HISTORIC LANDMARK COMMISSION
APRIL 27, 2020
PERMITS IN NATIONAL REGISTER HISTORIC DISTRICTS
NRD-2020-0016
3006 BEVERLY ROAD
OLD WEST AUSTIN NATIONAL REGISTER HISTORIC DISTRICT

PROPOSAL

Primary (east) façade and south elevation of 3006 Beverly Road. Source: Google Street View, March 2019.

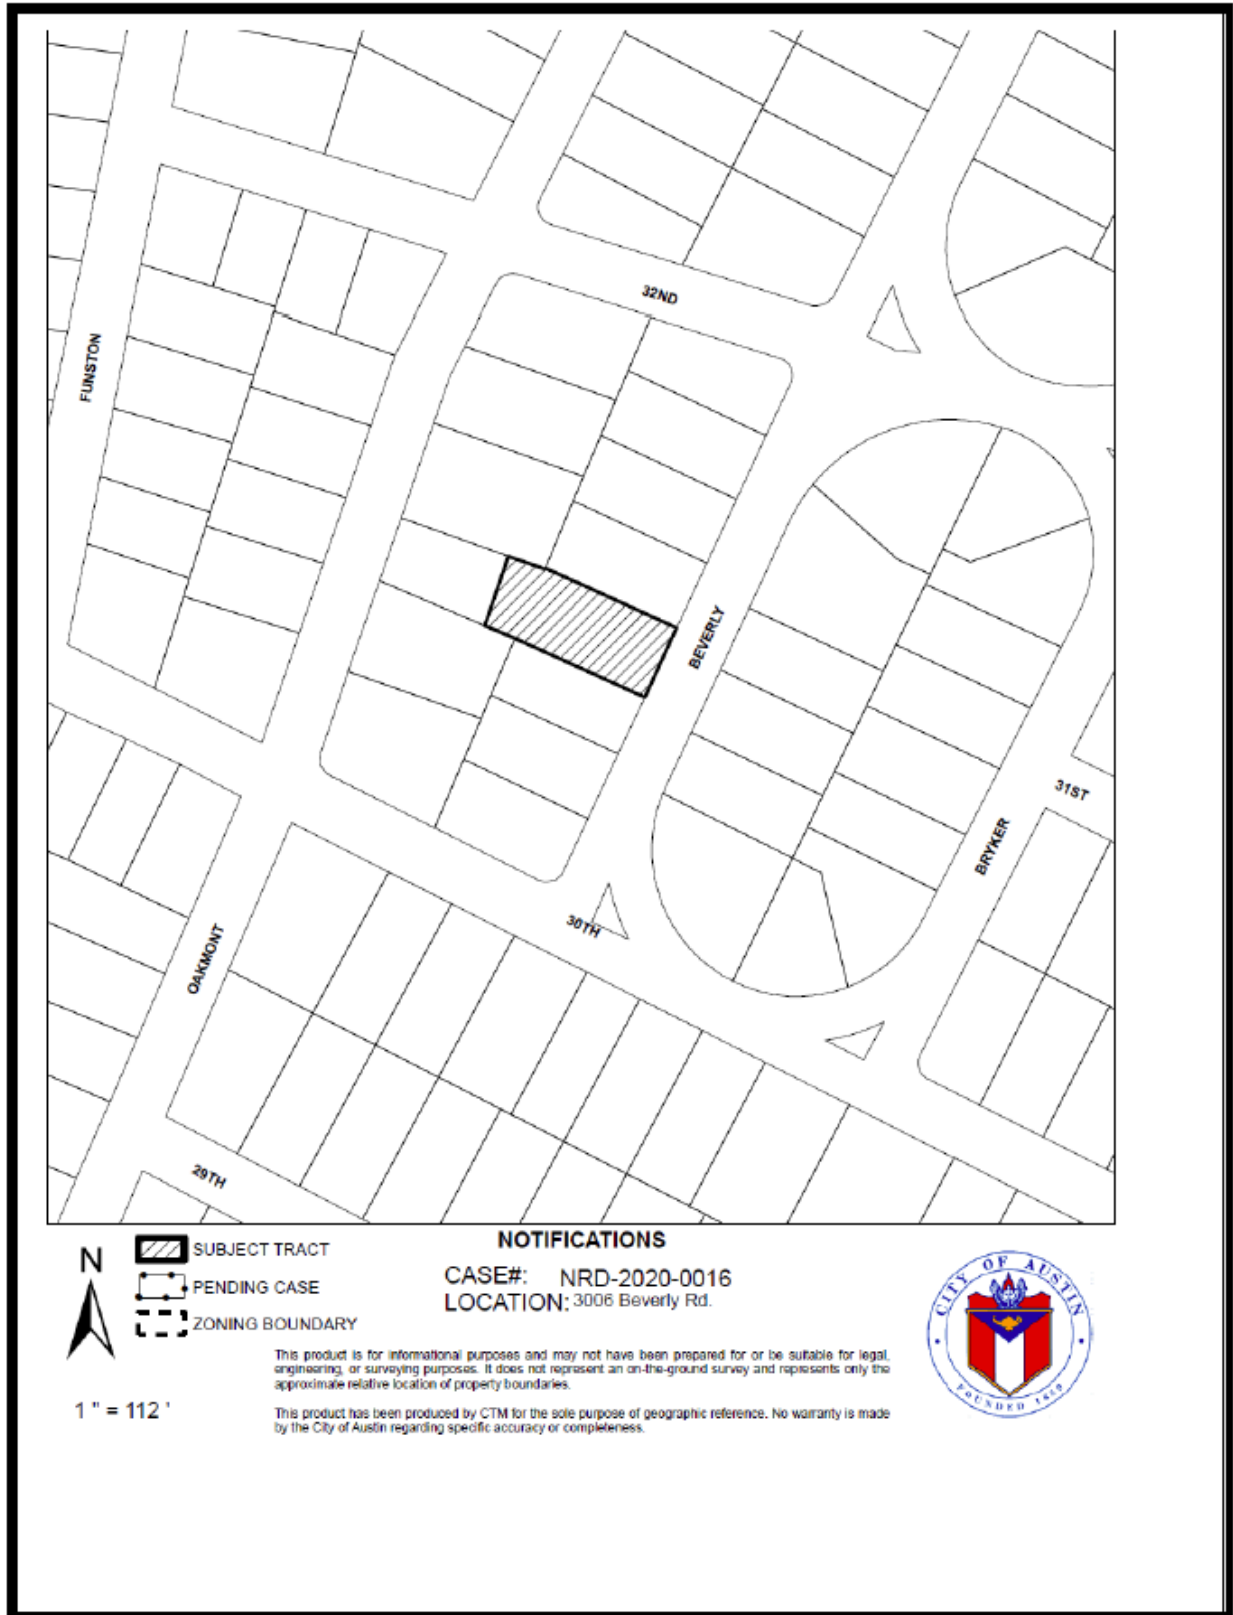
The project alters the historic building's roof form, as well as its entrance configuration and materials. Based on staff recommendations, the applicant has retained the frontmost gable end. However, the other substantial changes to the historic building mean that the project generally does not meet this standard.

The additions are differentiated from the historic house through lap siding and window proportions; and the multi-light windows and front-facing gable end of the second-story addition are compatible. However, the prominent location and massing of the second-story addition adversely impact the historic character of the house and are not compatible. The project generally does not meet this standard.

The second-story addition would be possible, though difficult, to remove in the future without impairing the essential form of the historic house. The project somewhat meets this standard.

Release the permit with the following advisory recommendations:

- Retain the second front-facing gable of the historic roof form;
- Retain the current entry configuration;
- Remove the proposed porch, especially the prominent front-facing gable end; and
- Increase the setback of the second-story addition.
